SUBJECT: Forwards response to 970605 RAI re request from relief from ASME Section XI, 1989 Edition to allow DPC to take credit for limited ultrasonic exams on pressurizer spray nozzle to upper head welds & certain SG shell circumferential welds.

Subject: Duke Power Company
Oconee Nuclear Station, Units 1, 2, and 3
Docket Nos. 50-269, -270, and -287
Third Ten Year Inservice Inspection Interval
Request for Relief No. 97-01
Response to Request for Additional Information

ATTACHMENT 1
RESPONSE TO STAFF QUESTIONS

Station O'CONNOR Unit 3 Rev. _____ File No. 35GA-WG8-3 Sheet 5 of 10
Subject _____

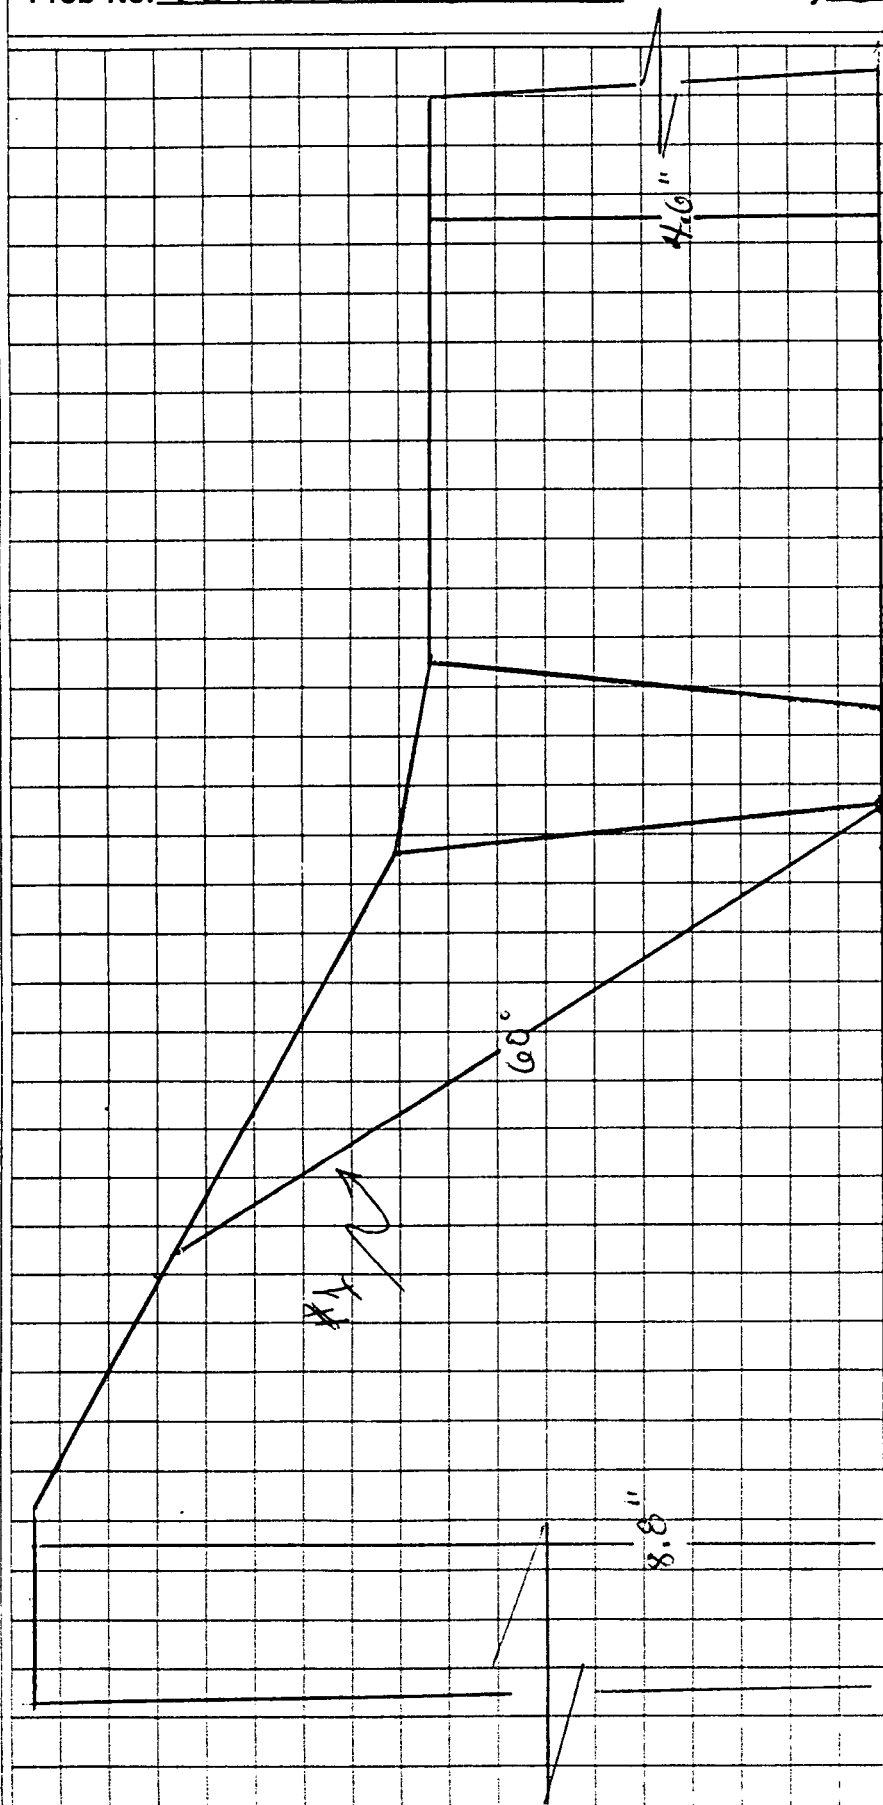
Based on Drawing No. ISI-OCN3-003 Rev. 1, it appears that circumferential welds WG8-3 and WG8-4 would also require inservice inspection examinations during the third 10-year interval. Have these examinations been performed? If so, please provide the Code-coverage obtained and discuss any indications found in these welds. If these examinations have not been performed, provide and approximate schedule for examination of these welds.

After plotting and reviewing previous data, it was determined that indication #1 with the 60° was a geometric reflector due to O.D. taper and I.D. geometry.
